STAFF REPORT

Application: BZA 2024-09

Request: Variance to the side setback to allow a building to be located 4' 2" from the side lot line rather than the required 7', and a related request for a 12' 3" building separation.

Property Address: 7714 Mohawk Drive

ARCHITECTURAL SITE PLAN

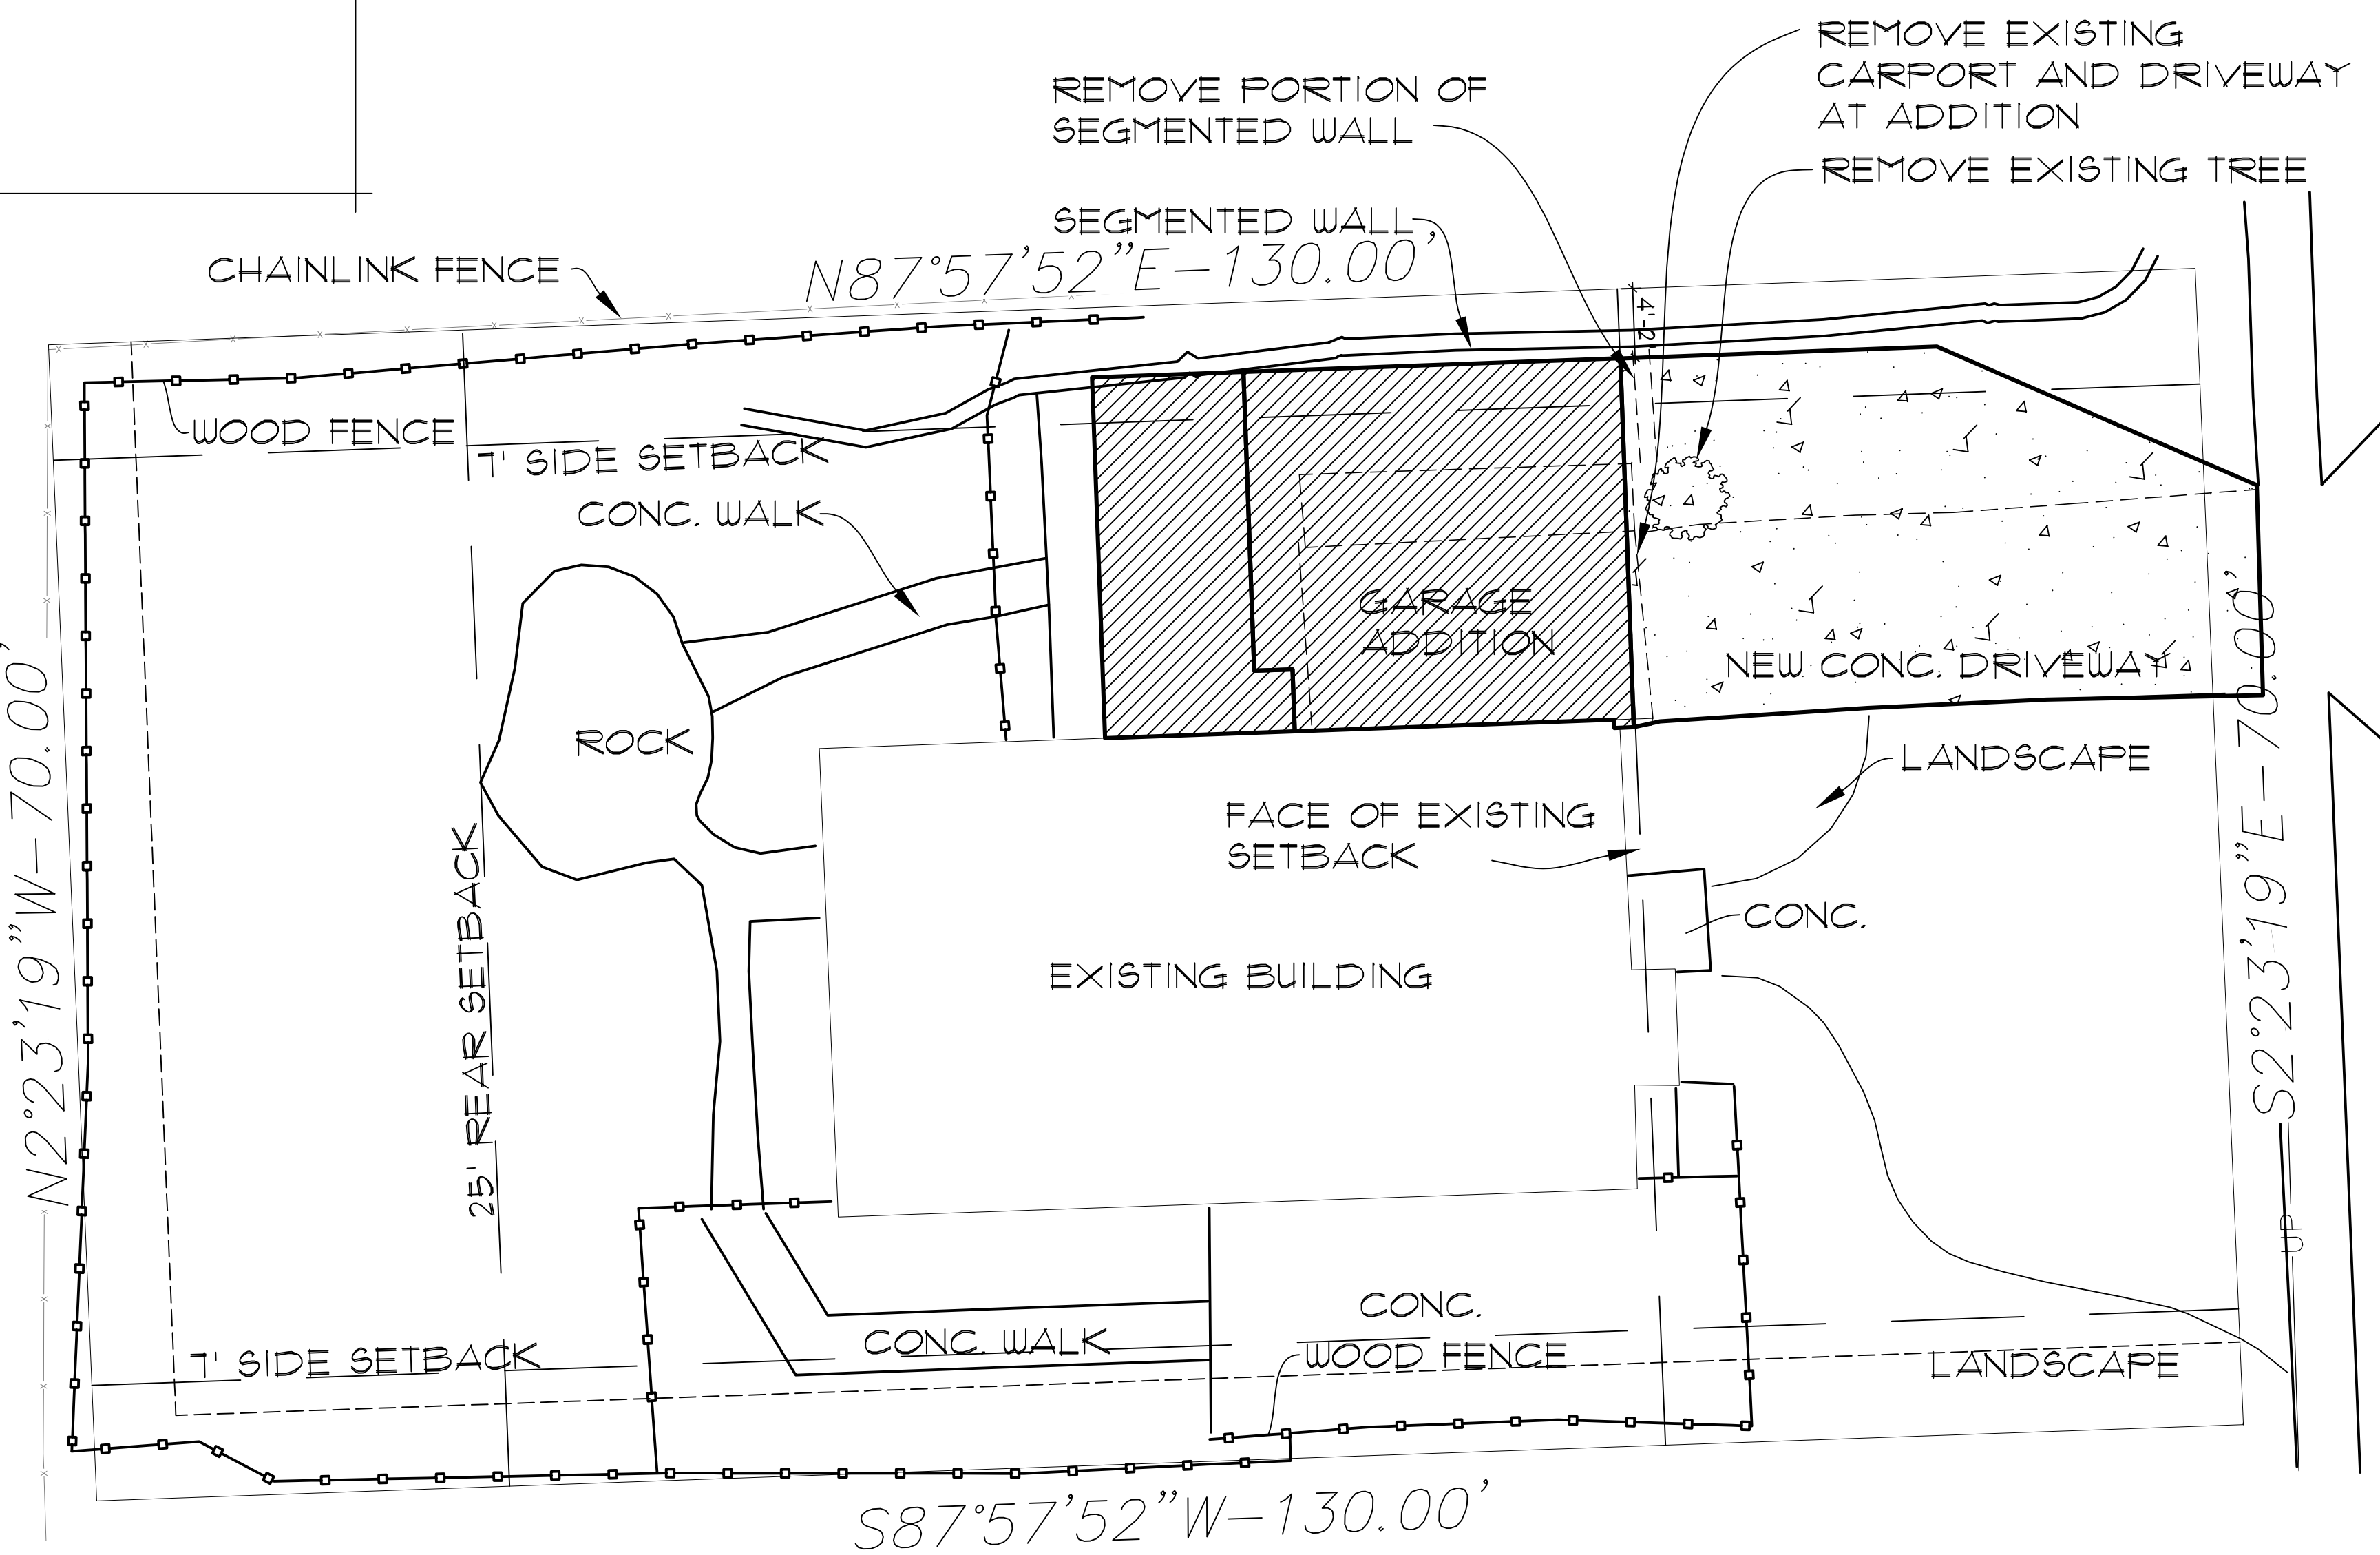
The applicant is requesting a variance from the side setback to allow the construction of an addition to the existing house 4 feet, 2 inches from the side lot line for a two-car garage. The addition would be approximately 32 feet in length, allow the replacement of an existing one-car carport and enclosed storage area on the north side, allowing for two cars and replacing the storage area to the rear of the garage. The garage would be 22 feet wide from the exterior wall of the garage to the exterior wall of the existing house. The garage 1 story matching the low slope roof of the existing hours.

This area of the lot abuts the side yard of the house to the north and with the variance the building would be approximately 12 feet, three inches from the adjacent building rather than the required 14 feet. The existing setback on the south side is just over 13 feet so the lot would maintain the required 20% cumulative side setback (70' wide lot requires at least 14' cumulative).

1. That the variance be granted only to the extent shown with the submitted application and based on submitted plans.
2. The variance, if approved, shall be recorded with the County Register of Deeds within 1 year of approval.

RIGHT SIDE - NORTH ELEVATION
SCALE 1/4" = 1'-0"

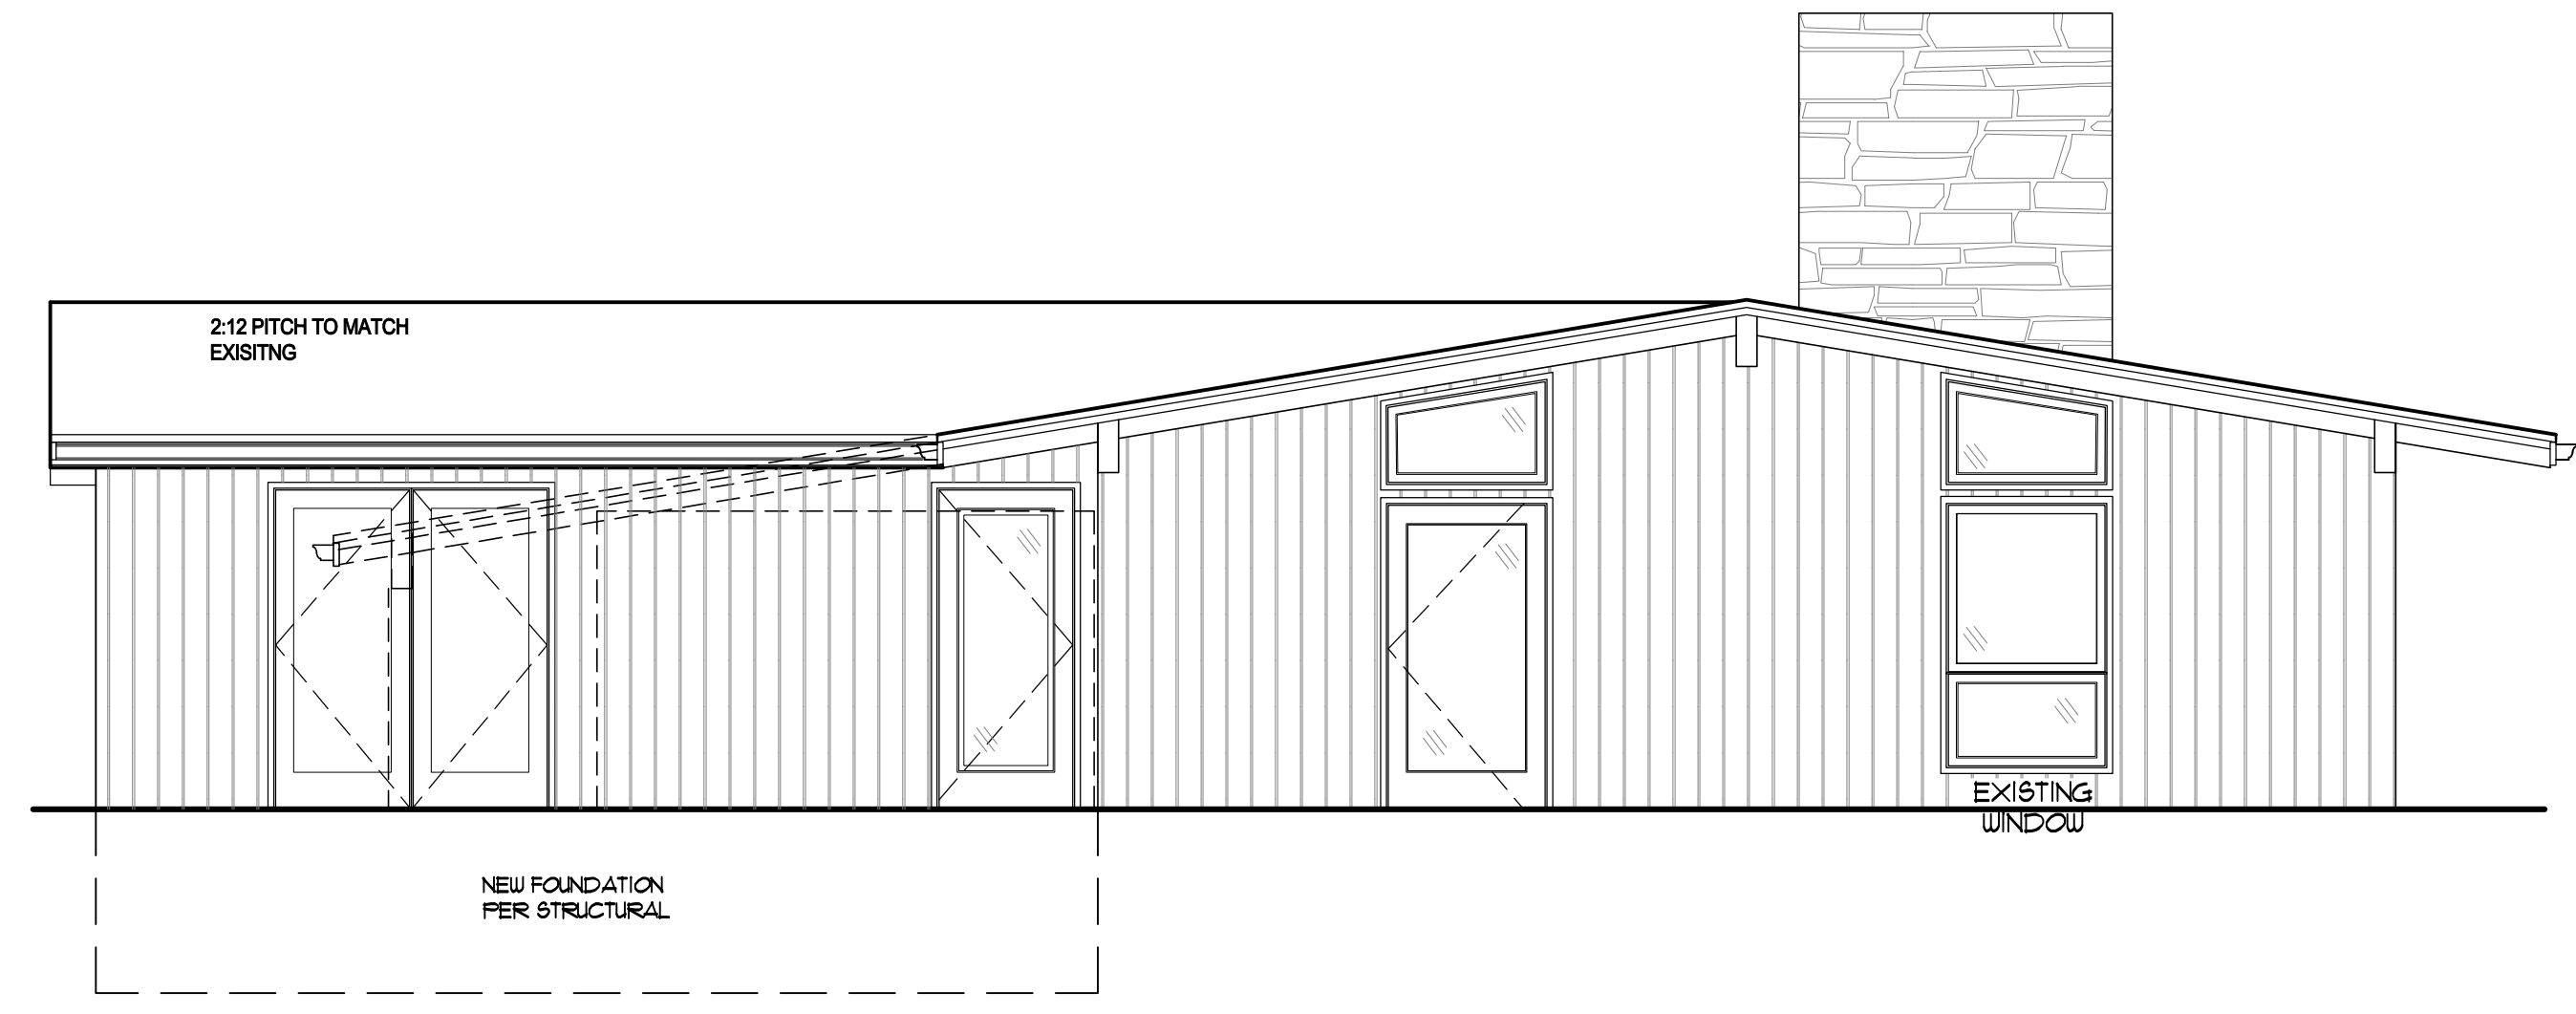
Although the proposed addition is closer than the house to the north, there is a lesser impact on this house than what could otherwise be built within the setbacks due to (1) the grade of the subject house being approximately 3 feet lower; and (2) the proposed addition retaining the 1-story profile and low-pitched roof, resulting in a very small overall elevation within the side setback.

The side setback standards are intended to manage relationships to adjacent lots and buildings. In this case the relationship to the adjacent building is limited due to the drop in grade, the proposal of a 1-story elevation, and the matching of the low-pitch roof profile. Additionally, the requested variance is minimal considering the nature of the project and permits a sufficient two-car garage. The application will meet all lot development and neighborhood design standards applicable to this lot, and particularly the standards intended to limit the scale and visibility of garages and driveways along lot frontages.
